Office Action Summary

10/534,436

TAKAMORI ET AL.

DETAILED ACTION

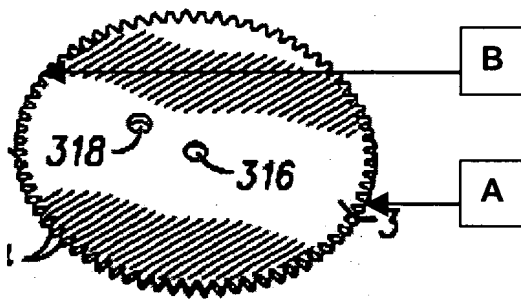
As to claim 1, Godston et al disclose a rotational supporting mechanism, in which a main body **220** and a cover **120** are superposed when in a closed position, and from the closed position, the cover is rotated 180 degrees in a planar direction in which the cover and the main body are superposed and stopped at a 180-degree rotational position when in an open position, the rotational supporting mechanism comprising:

an eccentric cam **318,310** rotating eccentrically with respect to the planar direction, the eccentric cam having a portion **A** (Figure 3 reprinted below with annotations) corresponding to the closed position at one rotational position with maximum eccentricity on a cam surface (maximum eccentricity being defined by a maximum distance from camming point **318**) and a portion **B** corresponding to the open position at another position with minimum eccentricity on the cam surface (minimum eccentricity being defined by a minimum distance from camming point **318**), the positions being 180 degrees opposite to each other; and

a pressing means **140,320,330**, which presses the cam surface of the eccentric cam by setting a pressing direction to the same direction as that of a line connecting both of the portion corresponding to the closed position and the portion corresponding to the open position, the portions being 180 degrees opposite to each other through the axis of the eccentric cam, wherein a pressing load is applied to the cam surface, rotation control over the eccentric cam being increased to stop rotational movement of the eccentric cam when the pressing means engages the portion corresponding to the

As to claim 2, Godston et al. disclose a mechanism wherein, when the portion **B** corresponding to the open position on the cam surface of the eccentric cam **318,310** engages the pressing means **140,320,330**, a control means **129** for controlling excessive rotation beyond the position corresponding to the open position in the same direction as that in which the eccentric cam is rotated 180 degrees to the open direction is provided (Figures 3-5).

As to claim 3, Godston et al. disclose a mechanism wherein the eccentric cam **318,310** has a recess (defined between adjacent teeth **314**) corresponding to the closed position at one point **A** with maximum eccentricity on the eccentrically rotating cam surface, to which a protruding portion **142** of the pressing means **140,320,330** engages,
